**Subject: Plan of Operations Modification Request – Addendum #2
Initial Permitting of CCR Landfill
Wisconsin Power and Light Company
Dry Ash Disposal Facility (WDNR License #3025)
Columbia Energy Center
Portage, WI**

Subject: Addendum No. 2 to Plan of Operation Modification Request WDNR CCR Code Update
Dry Ash Disposal Facility, License #3025
Columbia Energy Center
Town of Pacific, Columbia County, Wisconsin

Plan of Operation Modification Request WDNR CCR Code Update Addendum No. 2

3
24 **PROPOSED FINAL COVER (SAND DRAINAGE LAYER)**
SCALE: 1" = 2'

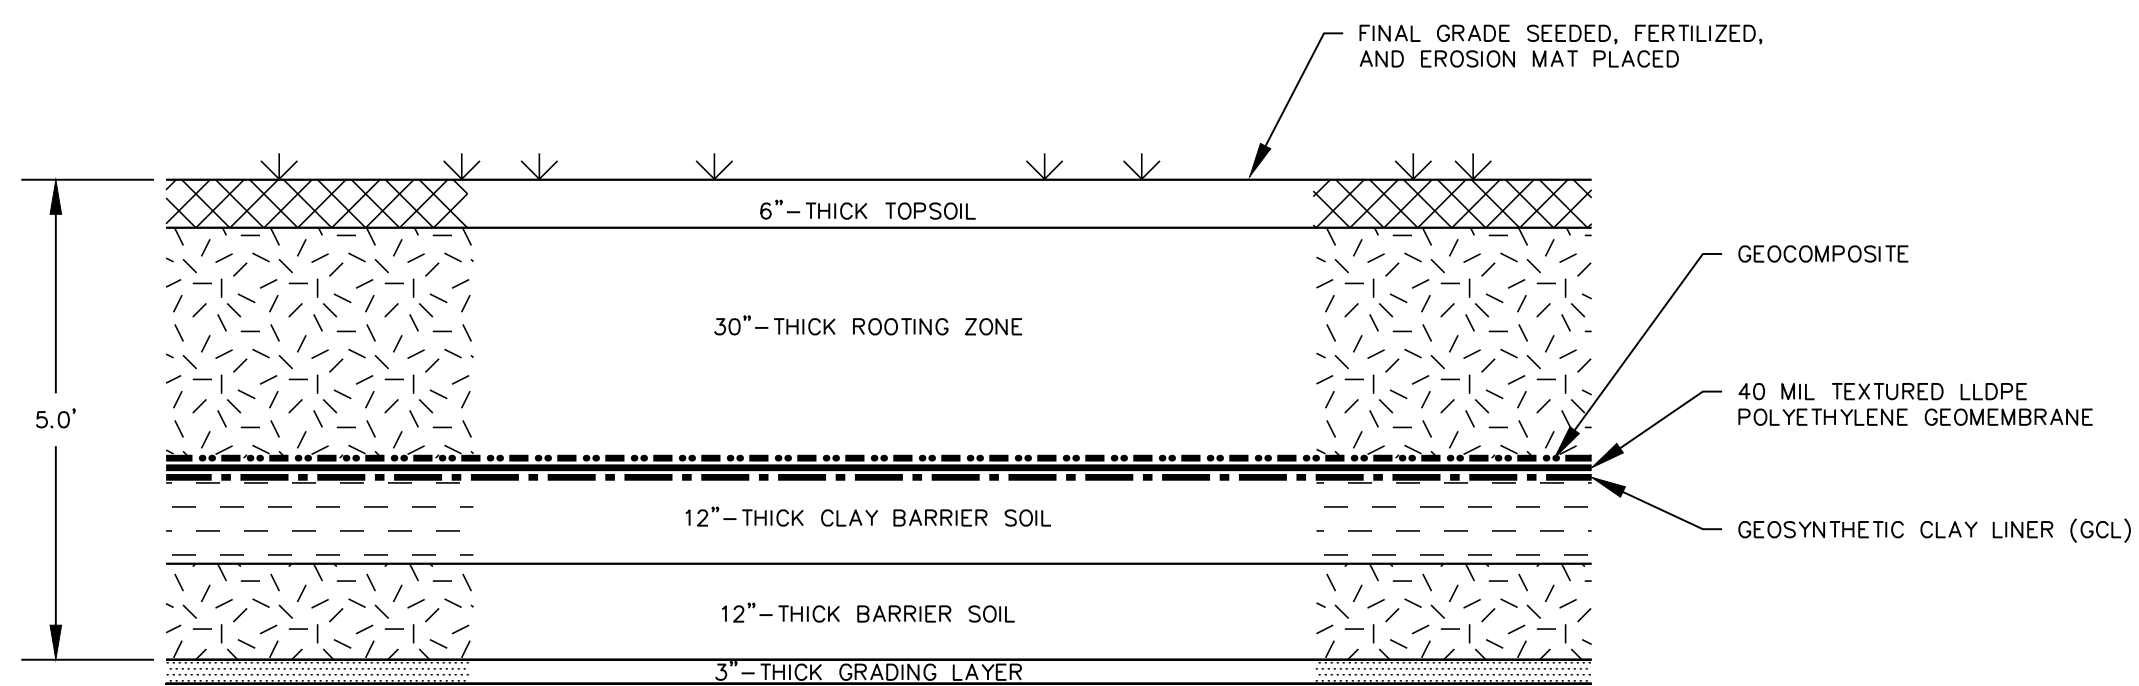
- “4. *S. NR 504.07(4), Wis. Adm. Code: Provide a revised final cover design that includes a clay capping layer or a soil barrier layer with a geocomposite clay layer (GCL). The current GCL final cover design does not include a soil barrier layer and therefore, does not meet the code requirements. Provide revisions to the design/construction items that would be affected by the addition of a clay capping layer or a GCL with a two-foot soil barrier layer, including the following:*

The proposed final cover system within a small portion of Module 1 and 2 (see **Plan Sheets 7 and 12** and **Detail 3, Plan Sheet 24**) will have a sand drainage layer instead of the geocomposite drainage with the following components from, bottom to top:

4
25
ACCESS ROAD OVER FINAL COVER
 SCALE: 1" = 4'

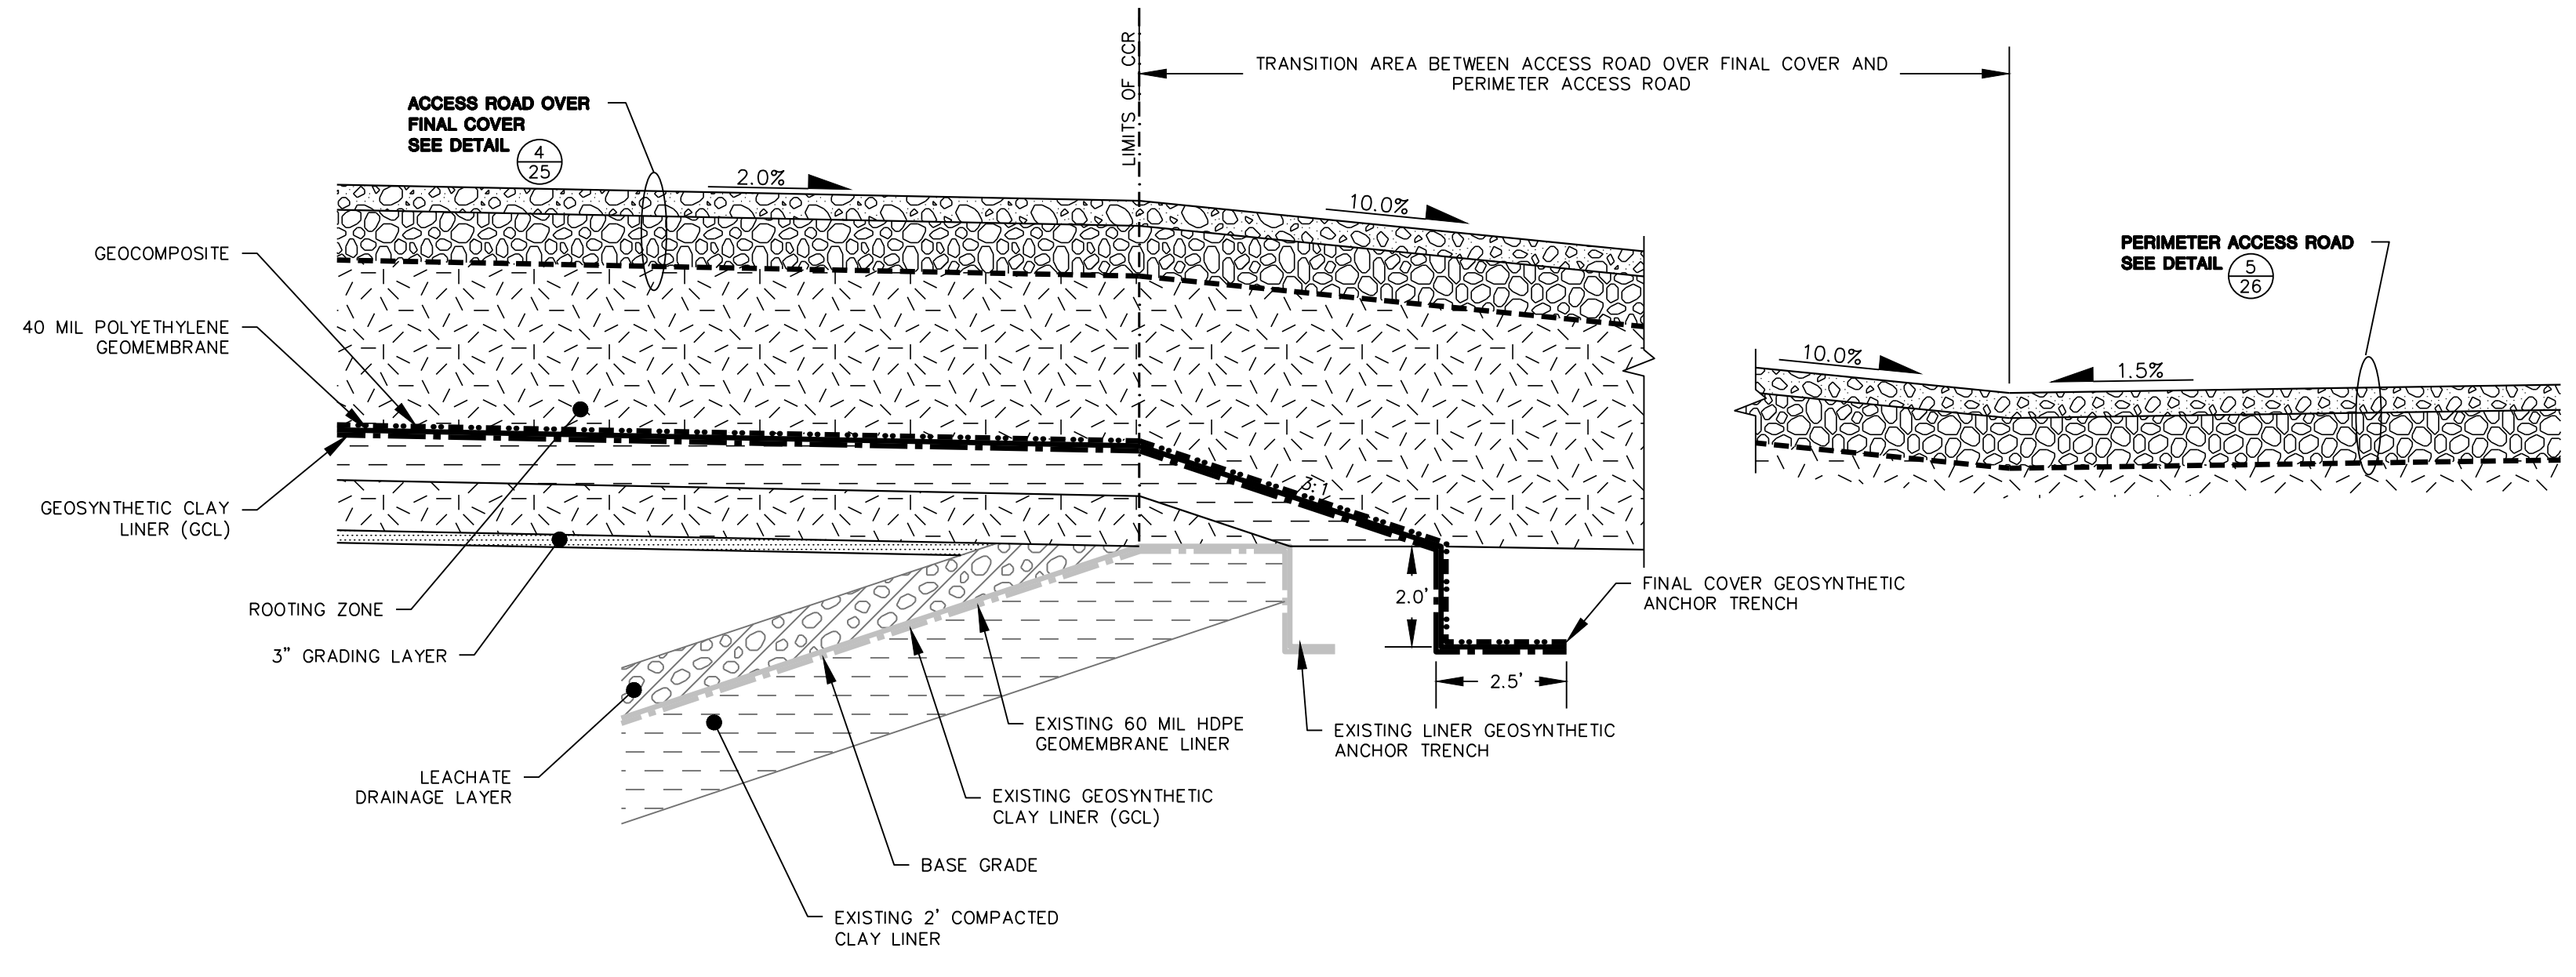
- Leachate/Surface Water Pond abandonment.
- Phase 1, Modules 5 and 6 Final Cover Permanent Haul Road.
- Specific monitoring well preventive action limits (PALs) for hardness and alkalinity.

The Phase 1, Modules 5 and 6 final cover permanent haul road has been designed as shown on **Detail 4, Plan Sheet 25**. Final grade waste slopes and access road slopes were evaluated in terms of global slope stability to determine the slope stability safety factors (**Appendix E.1**). Slope stability safety factors meeting the recommended minimum values were calculated based on the analyses. Unit gradient calculations are included in **Appendix E.1** to confirm that water infiltrating the final cover will be contained within the drainage layers (geocomposite) and will not result in unstable final cover slope conditions above the access road.
